WATTS BAR NUCLEAR PLANT (WBN) UNITS 1 AND 2 - BYPASSED AND INOPERABLE STATUS  
INDICATION (BISI) SYSTEM (TAC NOS. 77136 AND 77137)

RESPONSE TO THE NRC REQUEST FOR ADDITIONAL INFORMATION  
CONFORMANCE TO REGULATORY GUIDE 1.47  
BYPASSED AND INOPERABLE STATUS INDICATION (BISI)  
WATTS BAR NUCLEAR PLANT (WBN) UNITS 1 AND 2

FIGURE 1  
SAMPLE LOGIC TREE FOR  
AUXILIARY FEED WATER SYSTEM

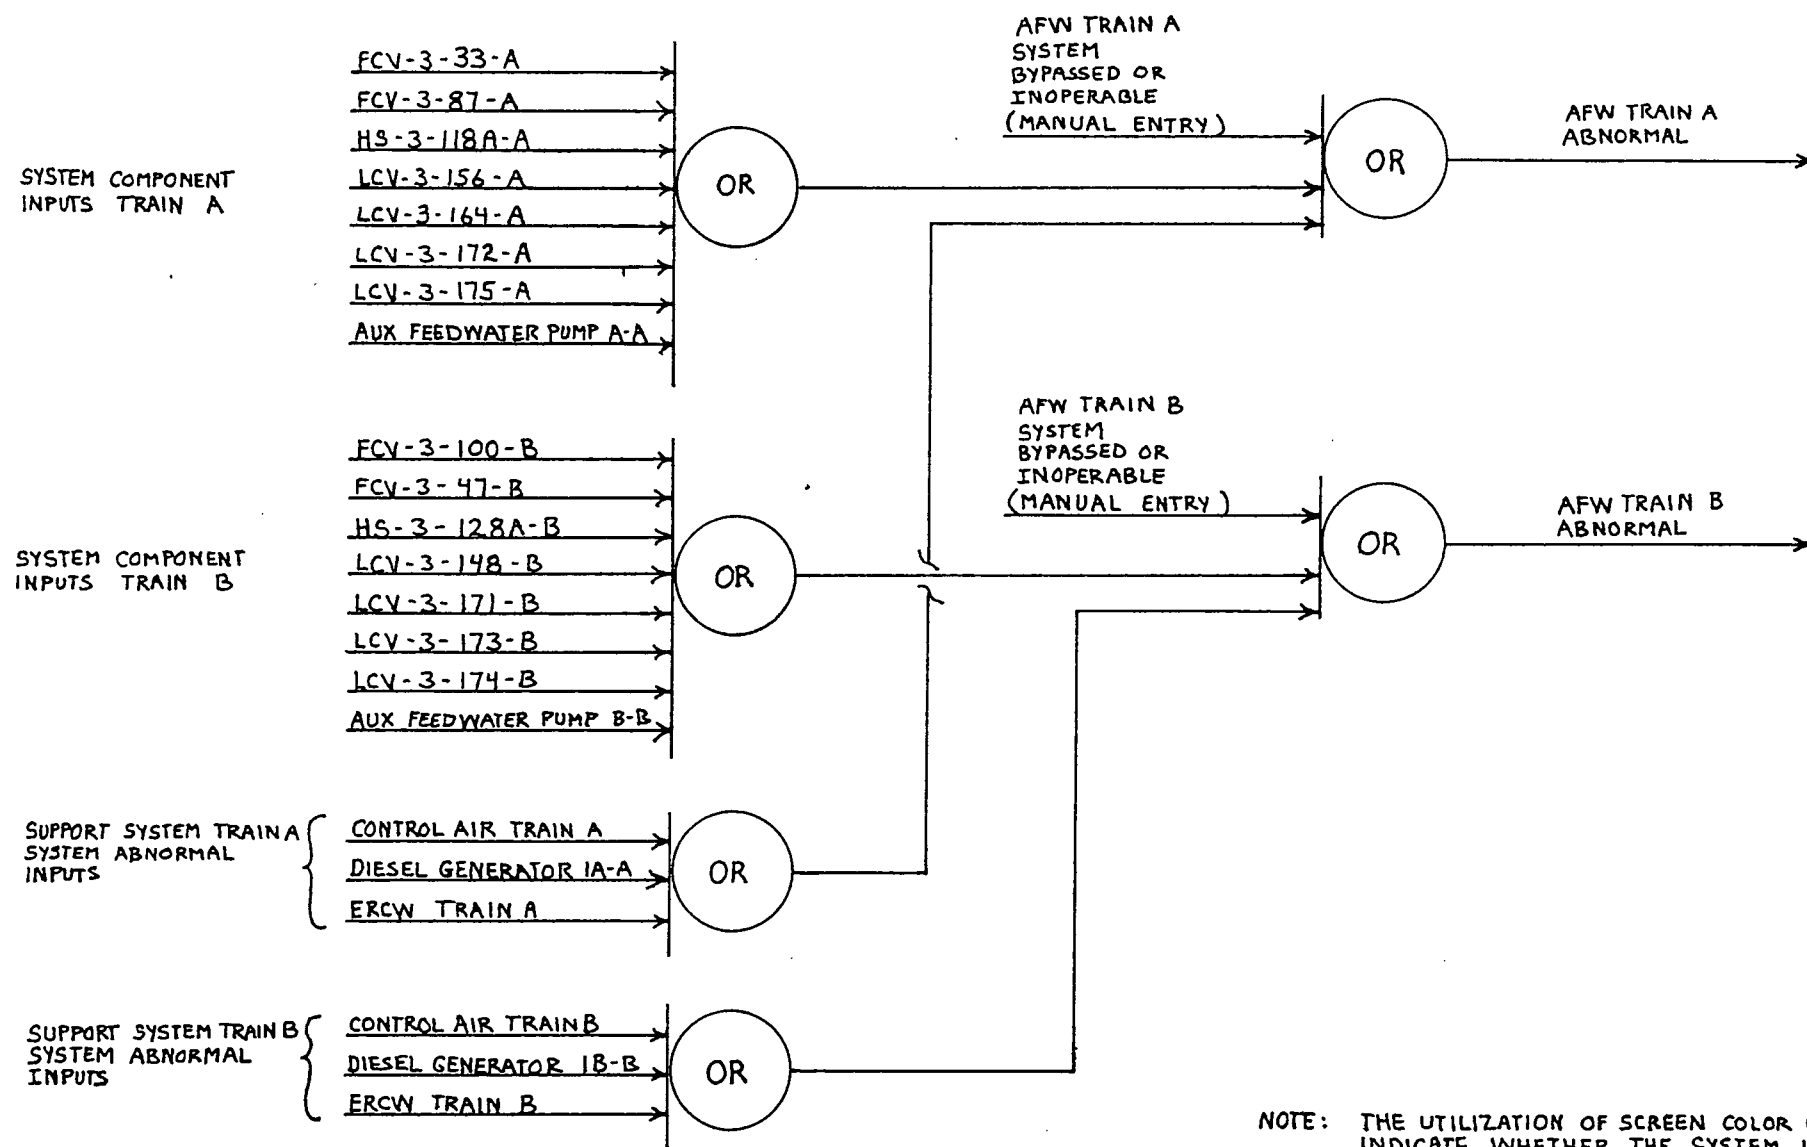
3. NRC REQUEST: TVA should provide logic diagrams indicating the monitored components and the logic trees indicating the system inoperable status.

TVA RESPONSE: The table to this enclosure contains the logic development for the BISI System for WBN Unit 1. Support systems are identified by the words "system abnormal" in the condition monitored column. Support systems of the same train as the system being monitored are logically combined in such a manner that if any one support system in the train being monitored goes into alarm it will cause an alarm for that train. Other inputs for each train of a system are logically combined such that any one input going into alarm will cause an alarm for that train. The logic diagram in Figure 1 demonstrates this logic for the Auxiliary Feedwater System. This logic is typical of the other systems listed in the table.
